TOLEDO CITY PLAN COMMISSION

REPORT
April 9, 2026

SITE PLAN

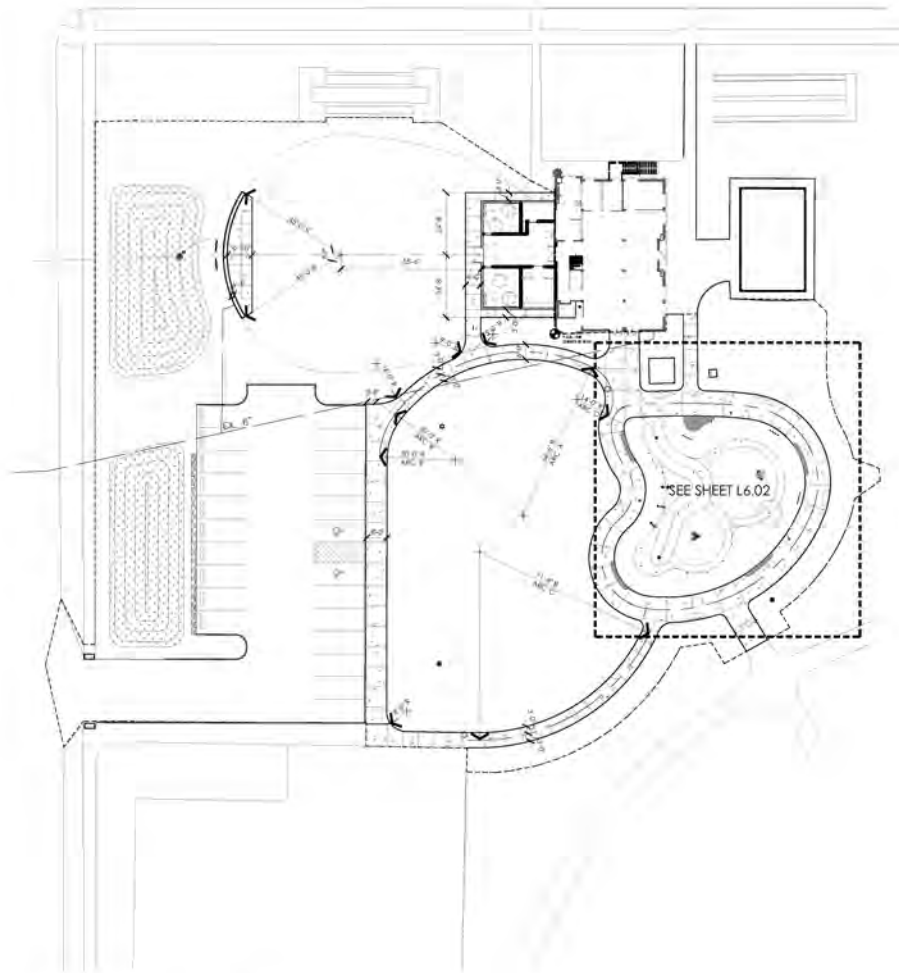
18. Per TMC§1107.1911, parking spaces laid out at a 90-degree angle shall have a width of at least nine feet (9'). **Not acceptable as depicted. A revised site plan with parking spaces nine feet (9') in width.**

- b. Perimeter landscaping must be installed along any parking lot area adjacent to a street, place, or driveway, or which is visible from an immediately adjacent property, and must include a continuous shrub row with a minimum height eighteen inches (18") to screen headlights. **Not acceptable as depicted. A revised landscape plan with a shrub row facing Elizabeth Street is required.**

LANDSCAPE PLAN

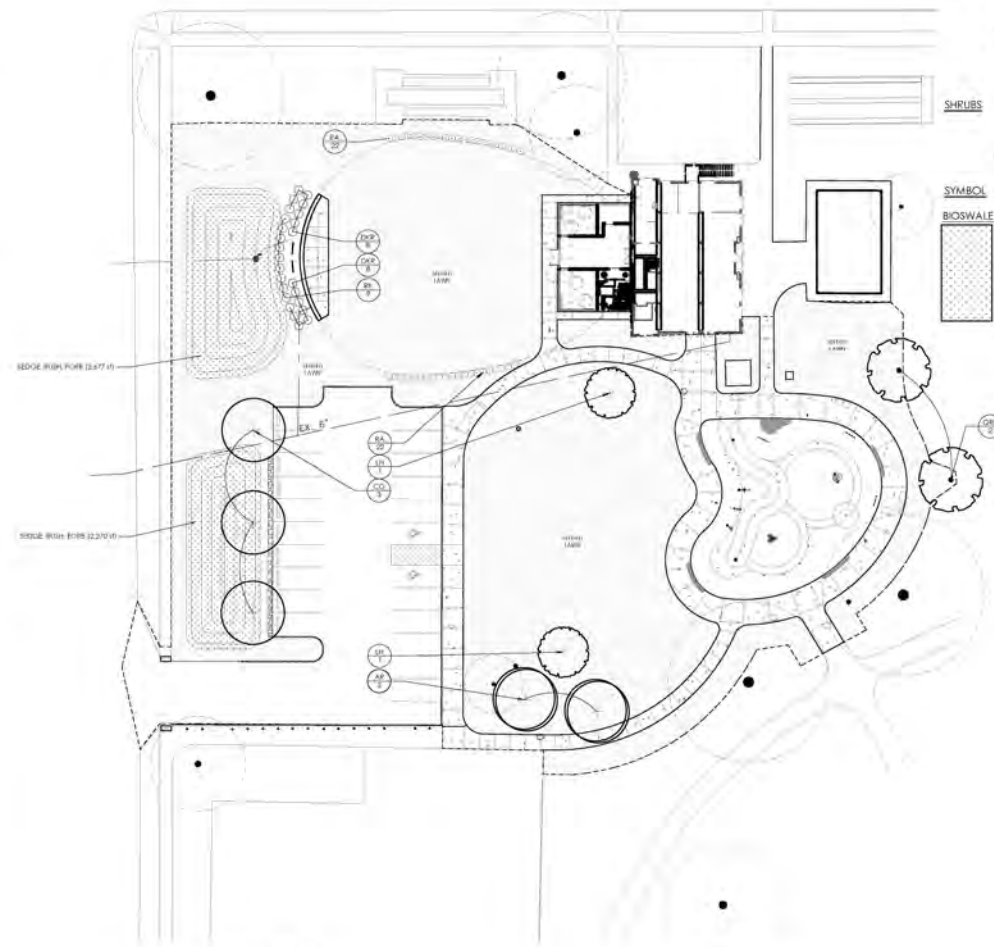
A perimeter landscape buffer shall be provided abutting the parking area and to visually screen all off-street loading facilities from view of Residential districts and public rights-of-ways. A minimum of at least one canopy tree must be provided for each 30 linear feet, plus a continuous shrub with a minimum height of 18 inches (when installed so as to achieve full screening at maturity). The landscape plan depicts three (3) hackberry trees, which are native to the Toledo area and are acceptable as depicted. A shrub row is required as a condition of approval, and native evergreens are recommended.

SITE PLAN

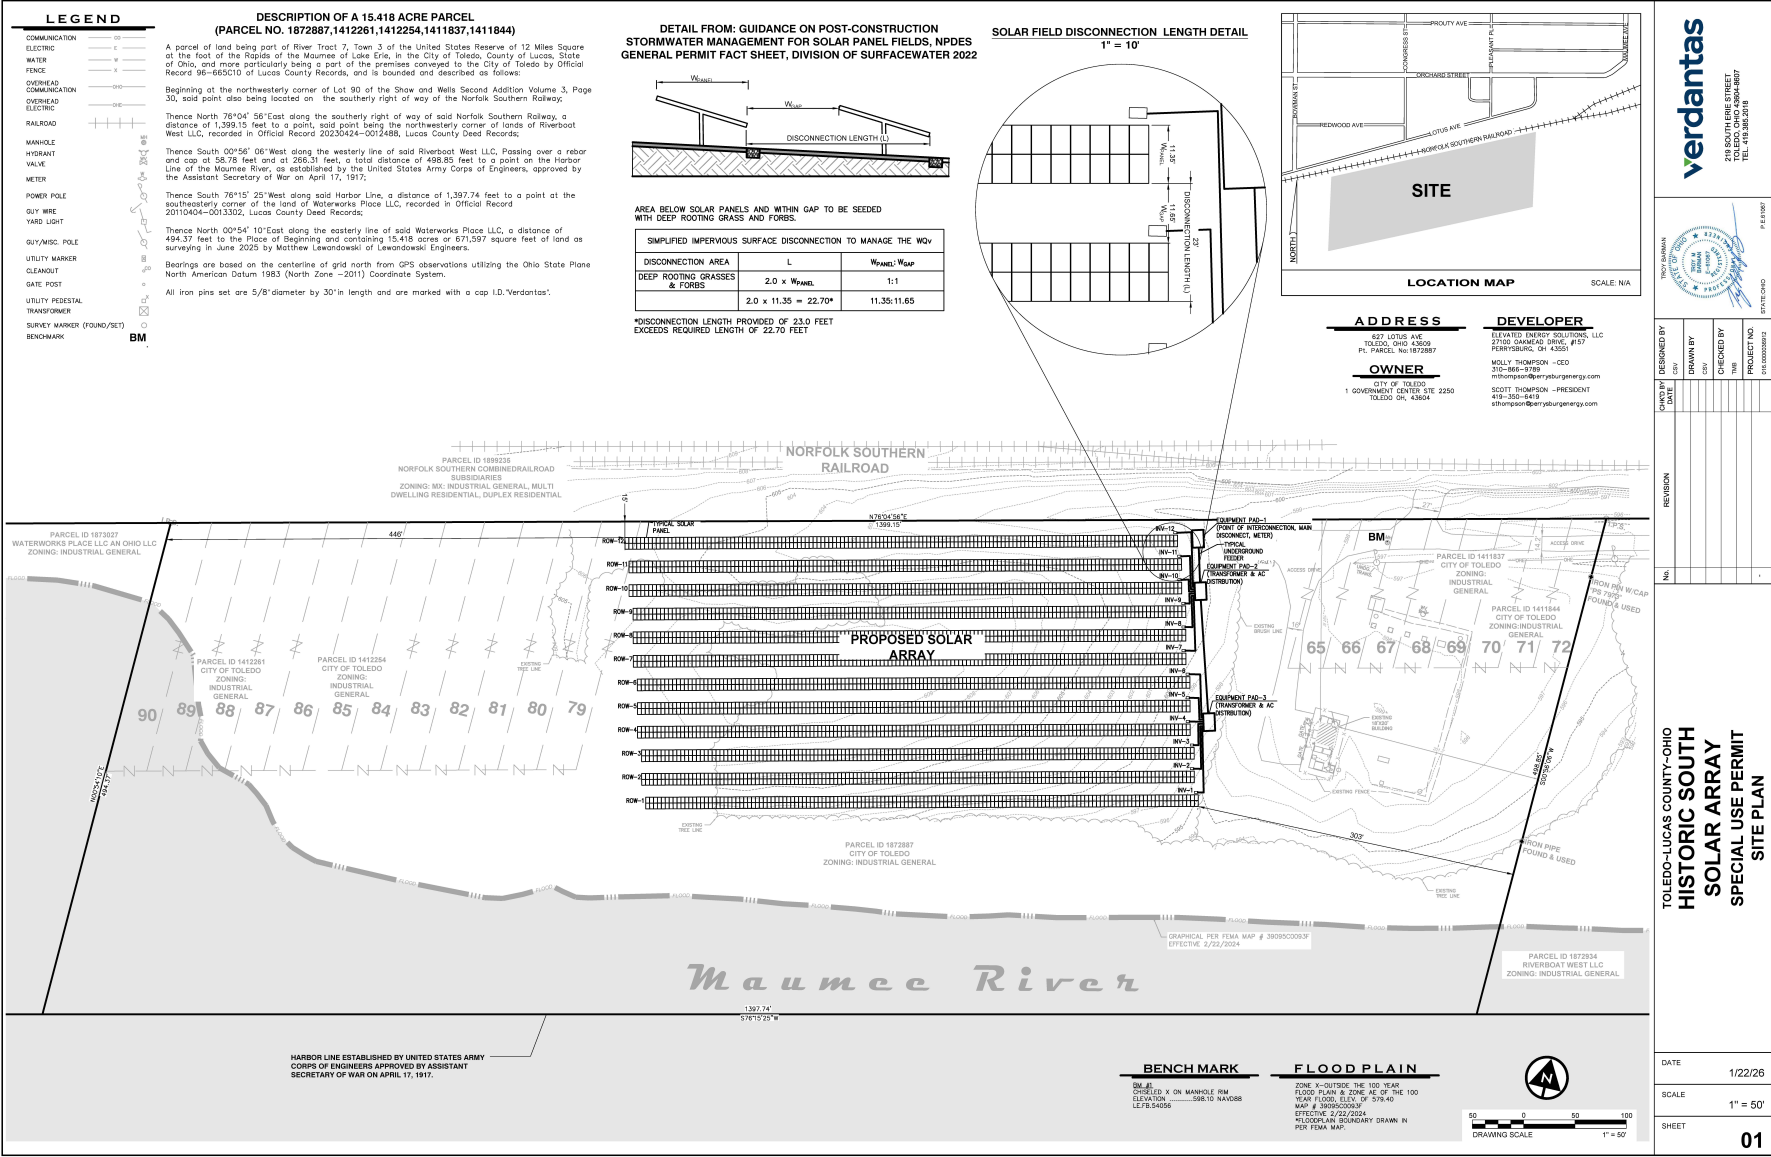
The subject site is essentially landlocked. The site plan does not show how access to the site is proposed. The City has an access easement in place for their use that extends to the east to Edwin Drive. As part of the lease agreement with the City, the applicant is required to secure an access easement for their use associated with the solar field. Access to the proposed development will therefore be from Edwin Drive to the east through an access easement agreement with adjacent property owners. The applicant is currently working to secure this access easement agreement and submittal of the agreement is listed as a condition of approval.

The City is requiring fencing to be installed as part of the lease agreement with the applicant to limit access to the pump station. The required fencing is not noted on the site plan, so it is unclear how service vehicles will maneuver once at the solar field. While off-street parking is not technically required, an area should be provided that enables vehicles servicing the solar field the ability to adequately maneuver in and out of the site and park when there since there are no immediate adjacent roadways. A revised site plan shall be submitted that illustrates the parking and maneuvering area and listed as a condition of approval.

The existing access drive to and through the site is not paved. Per TMC§1107.1906 - Surfacing and Drainage, maneuvering areas, aisles and driveways must be surfaced with concrete, bituminous asphalt, or other dust-free material other than gravel or loose fill, and be graded to drain all surface water towards the interior of the parking lot. In addition, the Fire Prevention Bureau has conditioned that the access road shall be designed and maintained to support loads of fire apparatus and shall be surfaced so as to provide all-weather driving capabilities. The access road and site drives will either need to be paved, or the applicant will need to secure a waiver from the requirement to surface the drives with a dust-free material in TMC§1107.1906. Staff is supportive of this request provided the surface provided meets the condition of the Fire Prevention Bureau.

14. Add a paved area for parking.
